Access Compliance Report Public Rights-of-Way (Curb Ramps)

Main Street: WOODSONG Cross Street: GREENVALE Location: E

ADA ID: RPAT220208115636 Ramp Type: Type 1 - Perpendicular Diagonal Initial Pass/Fail: Fail Overall Compliance: No Severity Score: 20

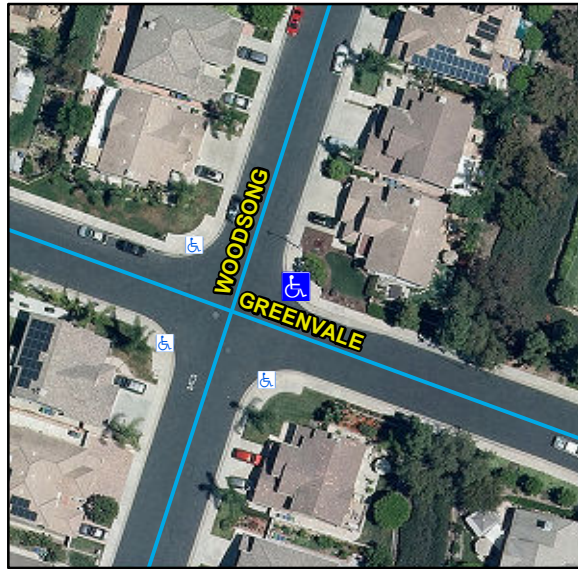
R304.2.2, R204.3, R304.5.1, R304.5.3, STD 1115

Compliance	Description	Data	Compliance	Description	Data
N/A	Ramp Length (in)	80	N/A	Flare Type LT	
No	Ramp Width (in)	45			N/A
No	Ramp Run Slope (%)	10.94	N/A	Flare Slope LT (%)	N/A
No	Ramp Cross Slope (%)	4.5	N/A	Flare Traversable LT	N/A
N/A	Landing Present	N/A	N/A	Flare Type RT	
N/A	Landing Length (in)	N/A			N/A
N/A	Landing Width (in)	N/A	N/A	Flare Slope RT (%)	N/A
N/A	Landing Run Slope (%)	N/A	N/A	Flare Traversable RT	N/A
N/A	Landing Cross Slope (%)	N/A	N/A	DWS Provided	N/A
N/A	Landing Movement Obstructed?	N/A	N/A	DWS Contrast	N/A
	Landing Movement Type	N/A	N/A	DWS Length (in)	N/A
N/A	Landing Shared	N/A	N/A	DWS Full Width	N/A
N/A	Clear Space	Yes	N/A	DWS Offset Left (in)	N/A
N/A	Clear Space To Crosswalk (in)	N/A	N/A	DWS Offset Right (in)	N/A
N/A	Marked Crosswalk 1	No	N/A	Marked Crosswalk 2	No
	Crossing 1 Direction	NW		Crossing 2 Direction	SW
	Marked Crosswalk 1 Width (in)	N/A		Marked Crosswalk 2 Width (in)	N/A

Remove & Replace Curb Ramp With Two New Directional Ramps or Equivalent.
